# City of Woodburn Community Development

## Memorandum

Subject: Building permit 971-23-000102-STR-02 Townsend Farms Planning

Division memo planning & zoning inspection result

Site southeast corner, June 12, 2024

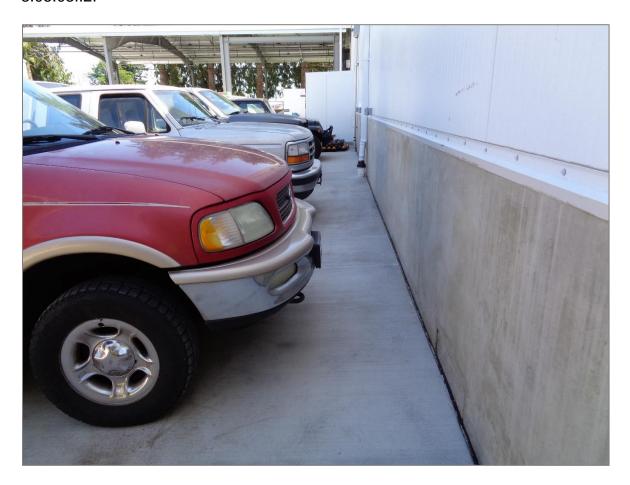
AA. CU3b(2): For CO as the Director allows instead of TCO, Condition CU3b(2) – the planting of minimum 3 site southeast corner trees.

Note: The contractor had a conflicting copy of site plan Sheet C100-01 with revision date 12/22/2023 versus the City copy with revision date 5/1/2023. The City copy indicates the walkway closer to the property corner and 3 newly planted trees, but the newer copy indicates the building perimeter walkway farther from the property corner and 5 newly planted trees. Based on the existing situation photographed below, clariy for re-inspection staff what to expect upon re-inspection.
